ENSTROM HELICOPTER CORPORATION

SERVICE DIRECTIVE BULLETIN

SERVICE NOTE NO. 0004

DATE: May 10, 1968
SUBJECT: Tail Rotor Blade Life - Part No. 28-15100
MODEL: F-28, All Serial Numbers
COMPLIANCE: Before Further Operation of the Helicopter

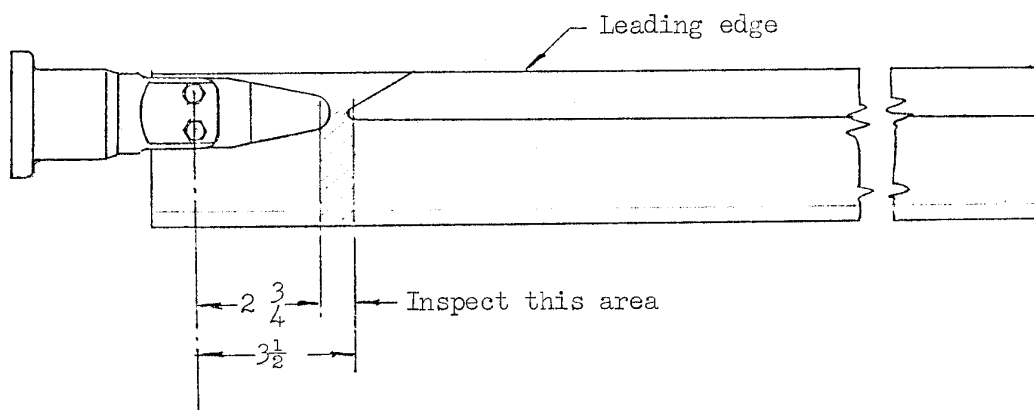
In addition, daily inspection of the blade skin for cracks in the chord-wise direction is required in an area $2 \frac{3}{4}$ to $3 \frac{1}{2}$ inches outboard of the retention bolts. (See sketch)

Should a crack be found, the blade must be retired from service, and we request that the Enstrom Corporation be advised of the defect.
